UNITED STATES PATENT AND TRADEMARK OFFICE

APPLICATION NO.	FILING DATE	FIRST NAMED INVENTOR	ATTORNEY DOCKET NO.	CONFIRMATION NO.
10/758,390	01/15/2004	Frederick Paul Renken	STL11265	5446

Office Action Summary	Application No. 10/758,390	Applicant(s) RENKEN ET AL.	
	Examiner Matthew G. Kayrish	Art Unit 2627

DETAILED ACTION

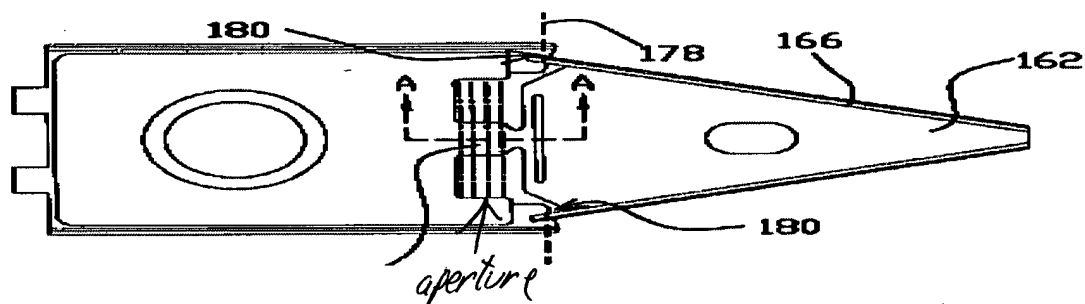
Regarding claim 1, Davis et al disclose:

A mounting region (figure 9A, item 168);

A bend region adjacent the mounting region (figure 9B, item 178) comprising:

A bend member (figure 9B, item 180); and

An aperture bounded by the bend member and the mounting region (figure 9B below); and

A load beam region with a damping material support structure (figure 9A, items 174 & 176) adjacent the bend member (figure 9A), the damping material support structure offset from the bend member and extending into the aperture (figure 9A, items 174 & 176 are in the aperture).
